**Contract ID#: DC00344**

**WBS Element: 2022CPT.03.17.20652, 2022CPT.03.17.20101, 2022CPT.03.17.20102**

**County: New Hanover and Brunswick Counties**

**Subject: Addendum #1: DISTRICT 3 PAVEMENT PRESERVATION**

*Location:*  
5505 BARBADOS BOULEVARD  
CASTLE HAYNE, NC 28429-5647

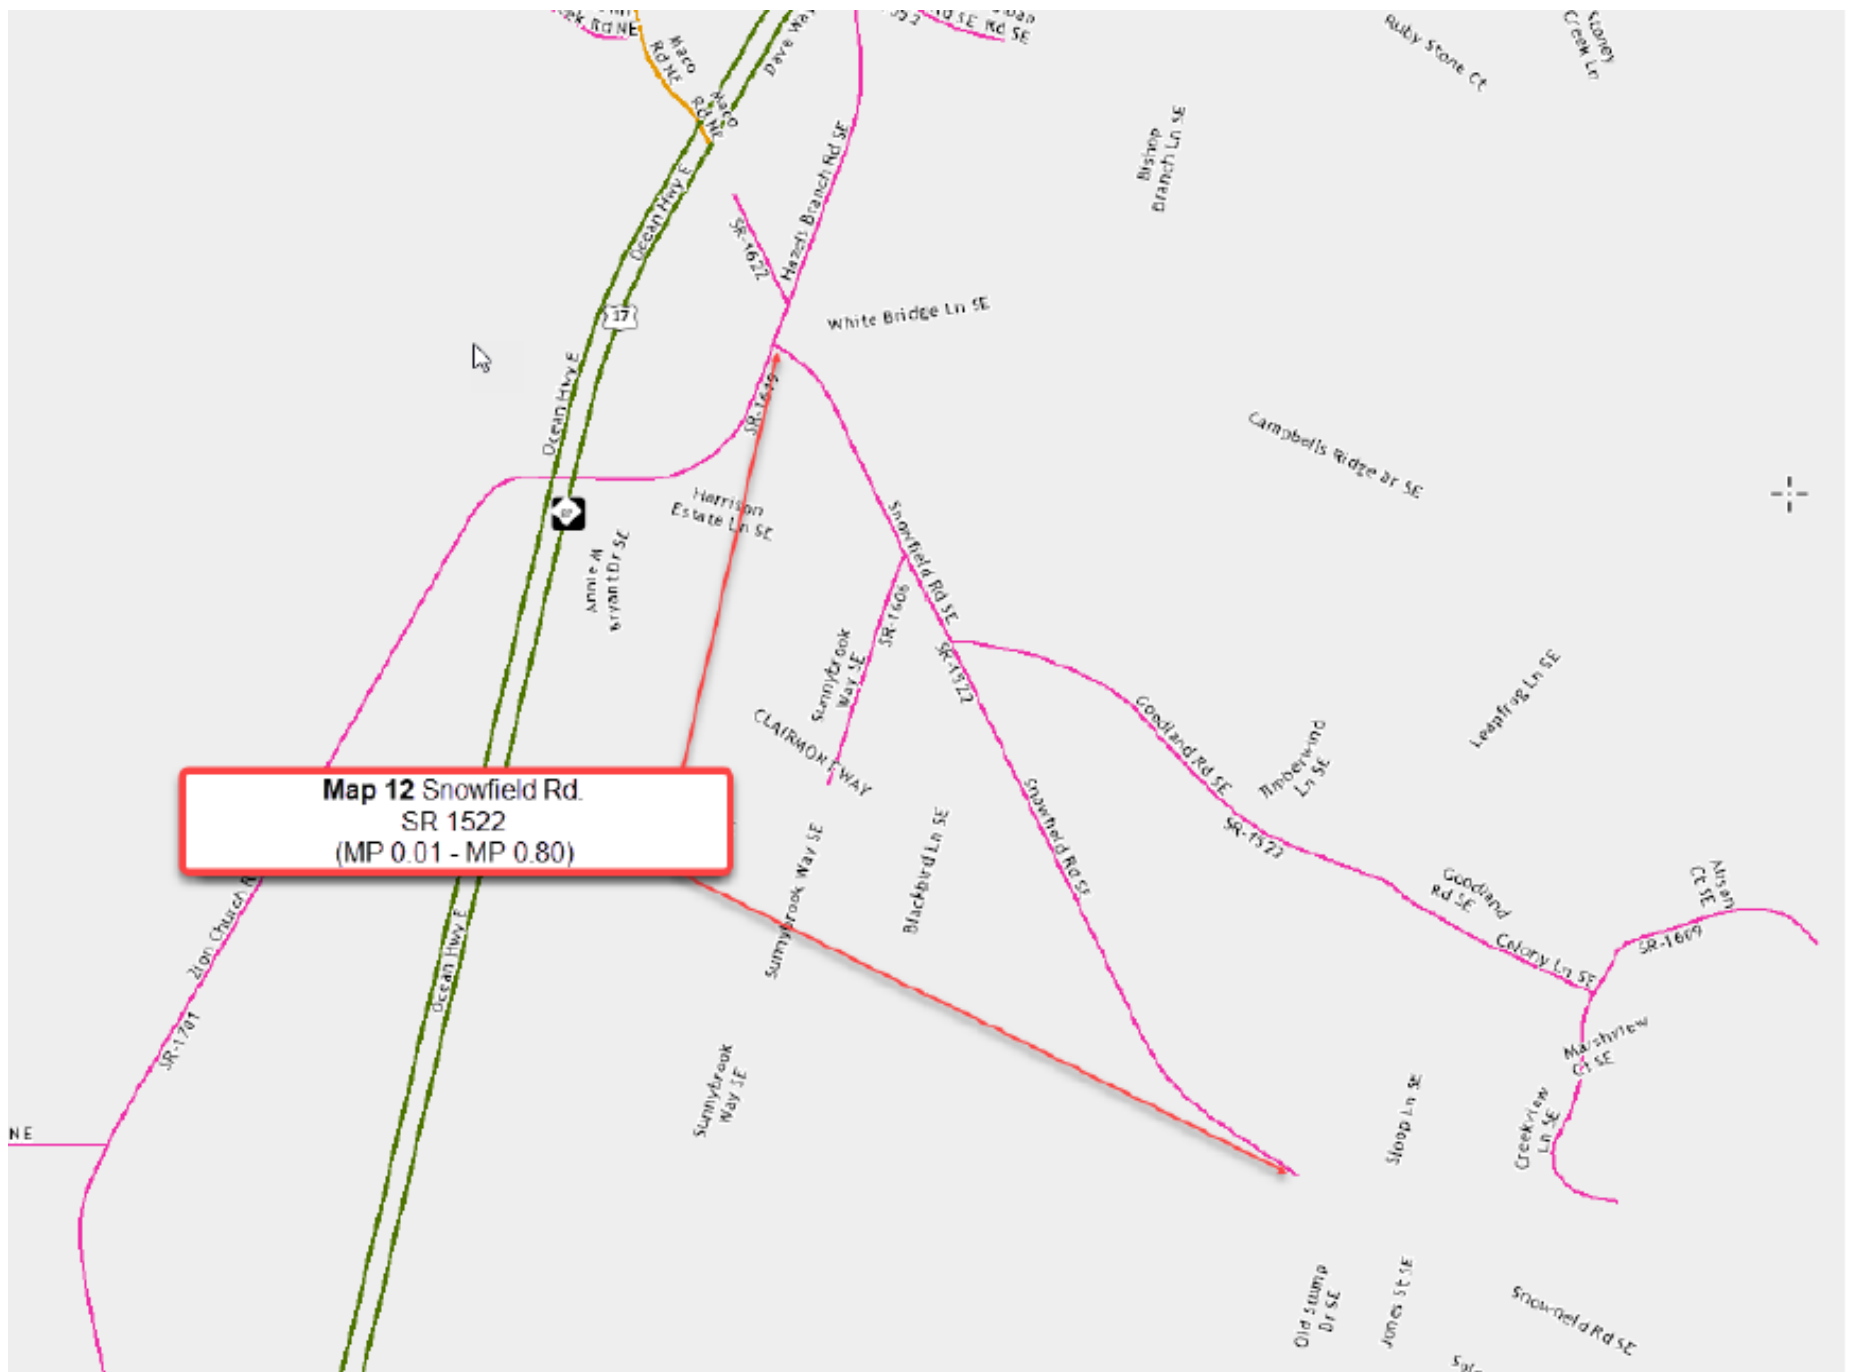
- 1- Project Plans (Plan Sheet No. 1, Map 2) has been revised in the *DC00344\_District 3 Preservation Plans*.
